AB58-COMM-34

Jim Dean
Former Director, WV Office of Miners Health Safety and Training 2/06 – 9/06
Co-Chair WV Mine Safety Technology Task Force
Dated 7/31/08
RIN 1219-AB58 Comments

These comments follow the order of the subject's occurrence in the published proposal. The term shelter is used throughout these comments interchangeably with refuge. The published text is provide in *Times Roman Italics Font* for reference with comments in **Arial Font**

Comment 45 concerning the statement:

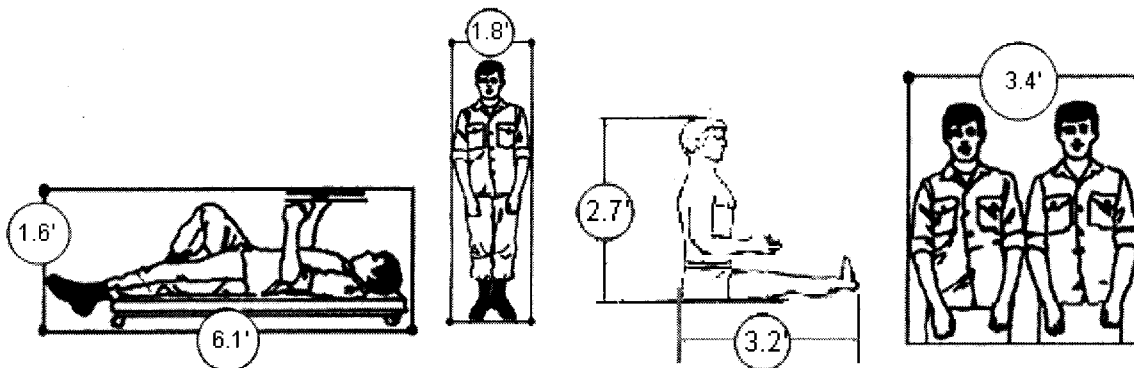
Section 7.505 Paragraph (a)(1) would require that refuge alternatives provide a minimum of 15 square feet of usable floor space and a minimum of 60 cubic feet of usable volume per person. MSHA believes that these proposed minimums are necessary to provide adequate room for miners using the refuge alternative. Usable space or volume means space or volume without stored items. The space and volume requirements are exclusive of the airlock space and volume. NIOSH design parameters requested 15 square feet and 85 cubic feet per miner. NIOSH stated that these recommendations were not to be considered absolute. Under this proposed provision, a space of 6 feet of length and 2.5 feet of width would amount to 15 square feet. If the same area has a height of 4 feet, the miner would be provided with 60 cubic feet of space. For mines with lower heights, the 60 cubic feet of space may need to be attained by increasing the length or floor area. MSHA solicits comments on these minimum space and volume requirements. Comments should be specific, including alternatives, rationale, safety benefits to miners, technological and economic feasibility, and supporting data. The area cannot be determined solely by the number of miners that would be using the refuge alternative. Miners would need some free space to operate components, drink, eat, and use the sanitation facilities—and tend to injuries. Additional space may be needed for suspended curtains, as part of a passive system CO₂ removal system. Also larger volumes seem to be more effective at dissipating heat.

This requirement is based upon a statement in the NIOSH report that was taken from a footnote in a 1986 report that referenced a 1958 Civil Defense publication (TB-5-3, May 1958). That document was researched by the NIOSH contract authors. If they had would have found it providing guidance for family fall out shelters that requested 80 cubic feet per person. It has no relevance to this application, a fact that has been confirmed to me by the NIOSH staff. If the MSHA staff would have called them they would have been told the same.

Fallout shelters were designed for occupancy by untrained civilians for periods of at least two weeks. Underground emergency shelters are designed for the survival of trained miners for a period of not more than 96 hours but most likely less than 48 hours.

Images taken from the US Department of Defense Human Engineering Manual (MIL-HDBK-759C) and modified to indicate English units verse Metric units.

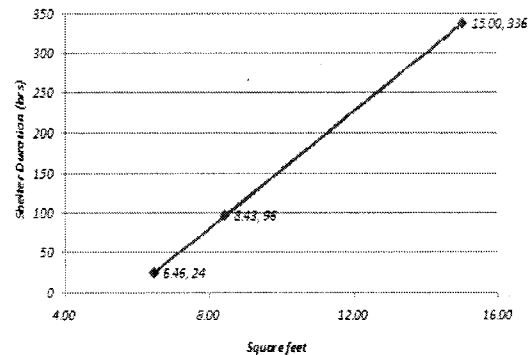
The US Department of Defense Human Engineering Manual (MIL-HDBK-759C) indicates that a supine man should have a space of 1.6 feet high by 6.1 feet long. It defines the space required for a man sitting to be 2.7 feet high by 3.2 feet long. If we assume that these are the two extreme positions in a shelter, we get a maximum volume of 29.6 cubic feet and a floor space of 10.9 square feet. (This value is arrived at by using the height of the sitting man, the length of the supine man and the design shoulder width.) As a point of reference, the South African regulation is 6.4 square feet of floor space with no volume value (Chief Inspector of Mines Directive B5, 14 Feb. 1994).

Since low-coal mines can result in interior shelter heights of 2 feet, the sitting position would not be applicable. In those situations, the volume would be limited to that of the supine position with a volume requirement of 17.6 cubic feet.

Additionally, the Department of Defense document identifies as 3.4 feet the space required for two men, which provides some guidance for the number of miners in given shelter length.

I: Pressure history of high explosive (HE) and thermobaric explosive (TBE) detonations

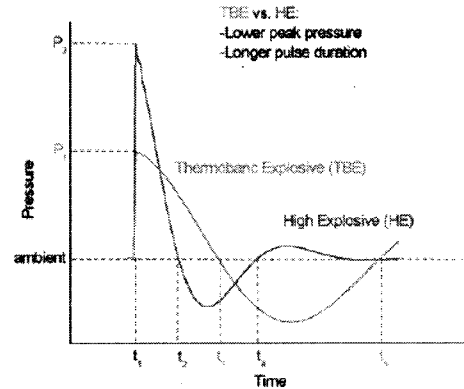
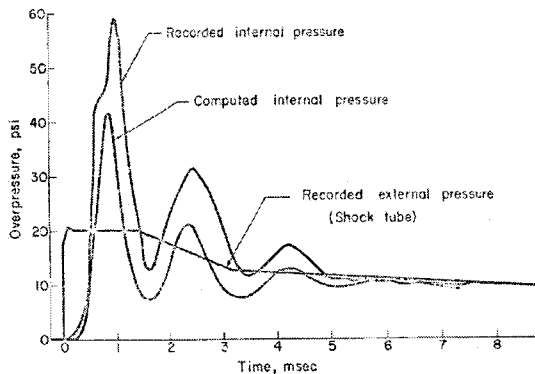
Agree. As discussed in the Comment 11 the period listed in the text is 0.2 seconds. This is effectively a static load and provides multiple means of testing. While there has been discussion of using a period in the few millisecond range, the seminal study on the subject of human effects of blast waves, "The Biodynamics of Airblast" by Clayton S. White, et al sponsored by the Defense Nuclear Agency in 1971, indicates that in closed environment such as building or mines that wave reflection and wave stacking result in not only higher effective overpressures but prolonged durations. An overpressure event of 15 psi in mine entry could easily produce an effective duration exceeding 0.5 seconds that would not affect the design criteria for a shelter but would increase the trauma of anyone in the blast zone.

Additionally the internal amplification of the overpressure due to wave stacking within the body found was found in these studies. An external pressure of 20 psi resulted in an in-lung pressure of 60 psi (see page 77 of the above report). The cause of fatality in animal studies has shown to be damage to the lungs.

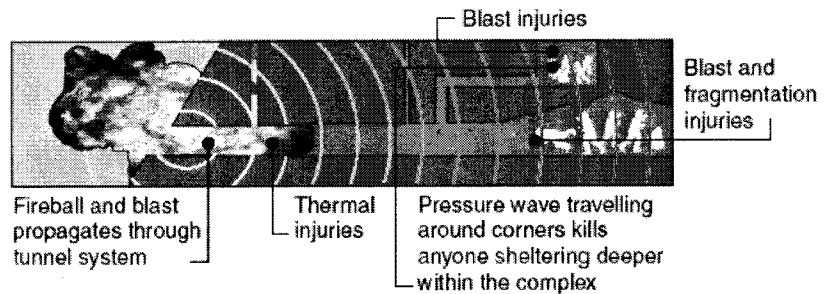
A recent article on their application included the image here. Similar articles on these weapons places severity of the trauma inflicted in a closed space such as mine tunnel at three times those experienced in open air. Current design criteria call for a design overpressure of at least 13 psi for these devices. Based upon these and the above values the 15 psi value for survivability of the shelter is sufficient as levels higher than that would not likely result in survivors.

All of this is relevant to an explosion in a mine in that it decreases the likelihood of survivors of an over pressure greater than the threshold values discussed above.

Comment 66 concerning the statement:

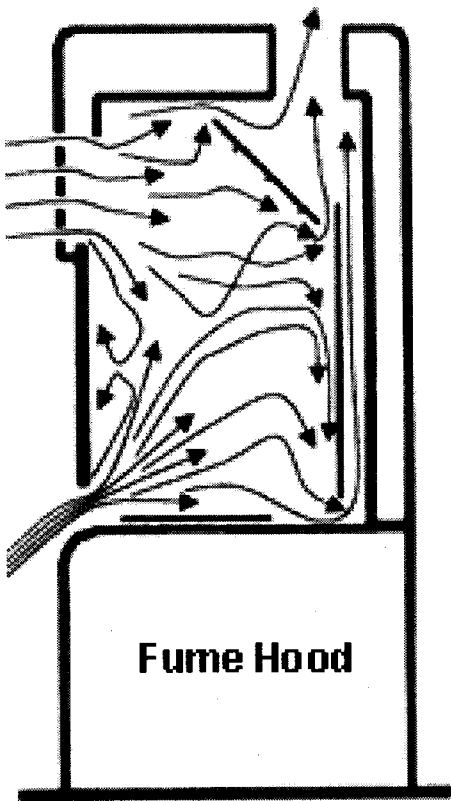
MSHA considered the enclosed space as similar to a loose-hood respirator using supplied air. Flair Corporation Bulletin 270 revision H (4-01) indicates that OSHA requires a supply air of 6 to 15 cfm (360 to 900 cfm) for supplied air hoods (continuous flow supplied air respirators) to purge accumulated carbon dioxide. The 12.5 cfm per person fell within this range. Engineering handbooks recommend ventilation rates in the range 10-15 cfm of fresh air per person for offices with 12.5 cfm per person being the midpoint of this range. MSHA believes that these quantities are conservative. However, they are design parameters for a life support system, which demands a more cautious approach. In addition, compressor wear reduces performance and the system will become less efficient with age. The Agency considers that the use of compressed air cylinders as the sole means of providing breathable air may be impractical and encourages mine operators to consider other options. As MSHA pointed out in PIB P07-03, a fan or equivalent method should be used to force fresh air into the hole with enough positive pressure to overcome total mine pressure to deliver sufficient quantities of breathable air. Compressor air intakes should be installed and maintained to assure that only clean, uncontaminated air enters the compressors. Mines should assure compressors have the capacity to deliver the required volume of air at the point of expected usage.

Open circuit respirators such as the one used in this analogy are designed with great care to ensure that the flow of air routes any contaminants in such a manner that they do not become trapped with the space. The document referenced could not be found however, the laboratory fume hood a more appropriate analogy. It is designed to ensure sufficient ventilation of large space such that hazardous gases are continuously removed from all corners of the space. The airflow and surfaces are designed to ensure sufficient turbulence of the high airflow (125 cfm) within the hood to ensure sufficient movement to carry any hazardous compounds from the space. This is a good analogy for what is needed to happen if an inflatable stopping were erected in a hazardous environment and the space needed to be purged.

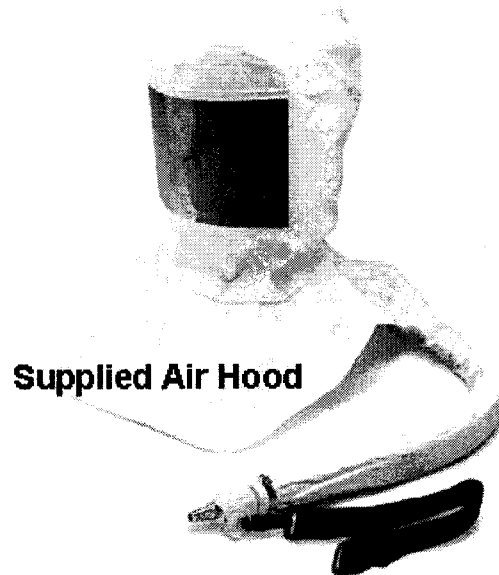
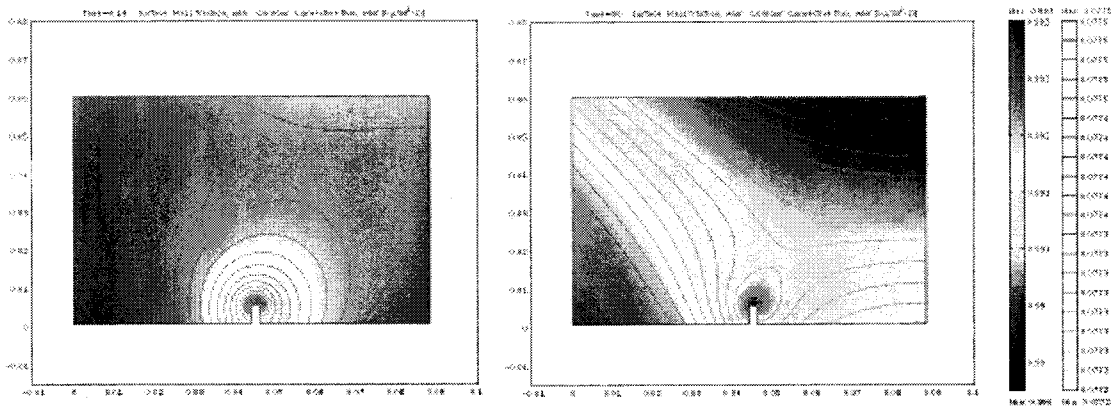
West Virginia University was asked to conduct a computational fluid dynamics model of PIB 07-03 with the assumption that the space is initially contaminated with toxic levels of carbon monoxide. The results could not demonstrate a means of purging the space using the MSHA standards.

For those looking at this in black and white, the dark red colors in the lower left of both images are above the fatal concentration of carbon monoxide and dark blue area in the upper right of the right image are carbon monoxide free.

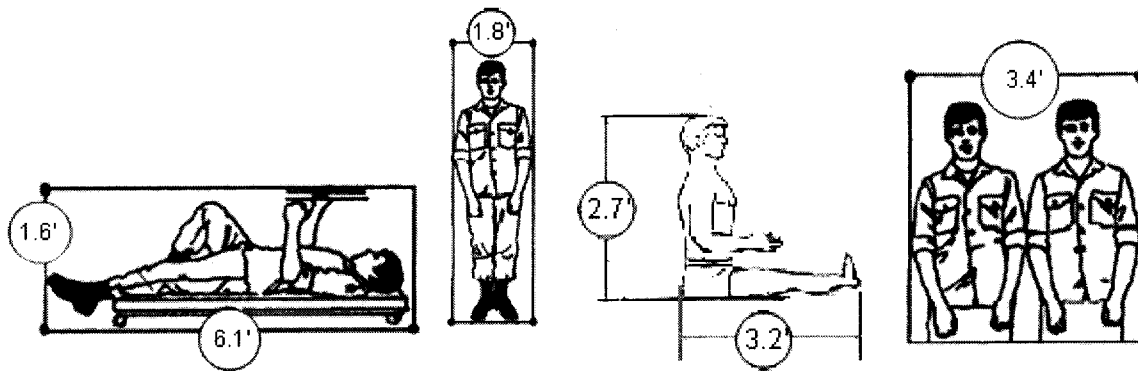
This requirement is based upon a statement in the NIOSH report that was taken from a 1958 Civil Defense publication (TB-5-3, May 1958) providing guidance for family fall out shelters that requested 80 cubic feet per person. It has no relevance to this application.

Fallout shelters were designed for occupancy by untrained civilians for periods of at least two weeks. Underground emergency shelters are designed for the survival of trained miners for a period of not more than 96 hours but most likely less than 48 hours.

The net effect of this provision would be reduce the effective occupancy of current shelters by up to 50% and more than double their number underground. This increases

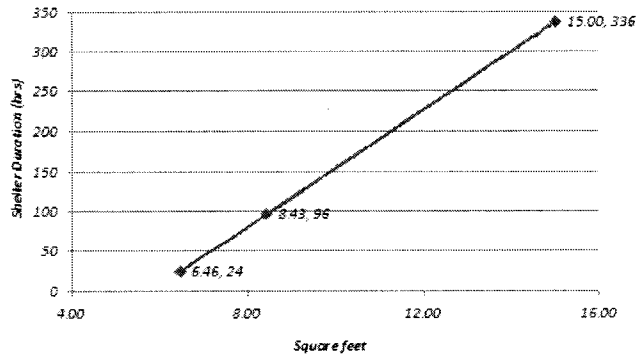
Another approach that has been requested by some could be to extrapolate between the values utilized in South Africa mine shelters since the 1990's of and those of the U.S. Navy for 100 men in fallout shelters for 14 days. Using the approach in graph on below this would result in a value of 6 square feet.

However, it is important to remember that emergency shelters are the last resort in the event of an accident to ensure survival not to ensure comfort. As one miner told me after a training session on all the things we have done to improve their chances for escape, “With all these extra escape additions if I have to, the decision to get into a shelter or not boils down to the shelter or a body bag...it’s not that a hard a choice.” Comfort is not the main consideration...survival is the ONLY consideration.
